ENGINEERING CHANGE REQUEST (ECR)

CUSTOMER DRAWING NO. D972472

DRAWING TITLE ~~BK~~ BELLOWS REMOVAL I-BERM JSG

REVISION: FROM A TO B

972472
1 of 3

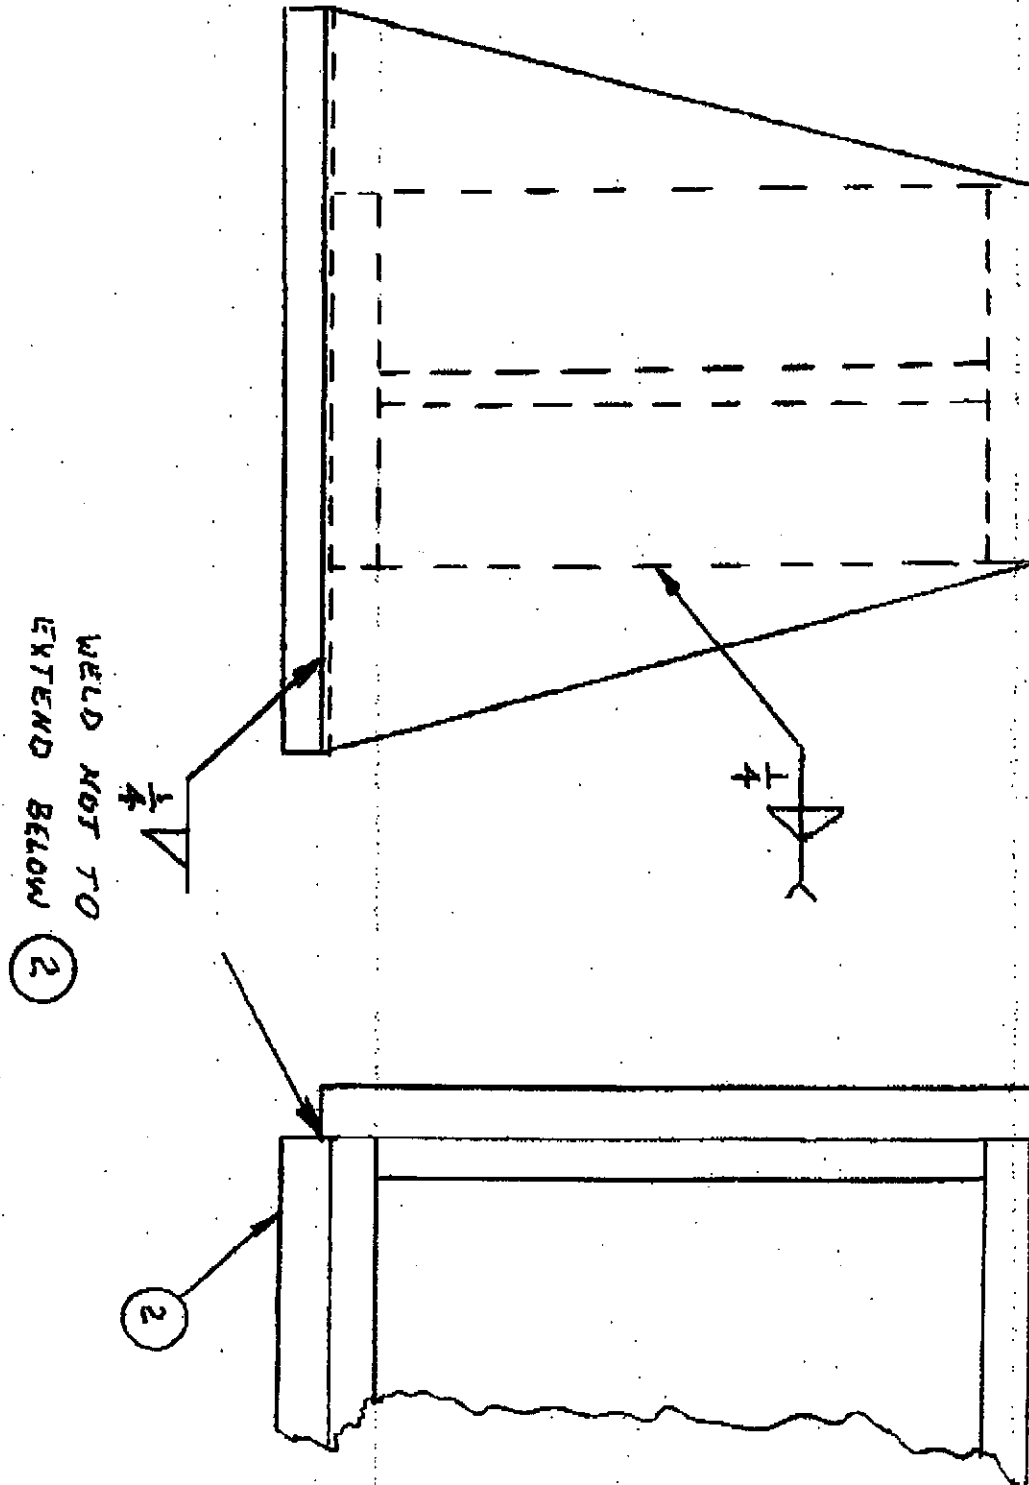
- ① ZONE 5D ELIM. TAPPED HOLE AT 11.500
- ② ZONE 1-3A DELETE ITEM 7
- ③ ADD 3/8 GUSSET (SHEET 2 OF ECR) TO P/L

- ① & ② CUSTOMER REQUEST
- ③ REDUCE DISTORTION OF DWG ITEM 2
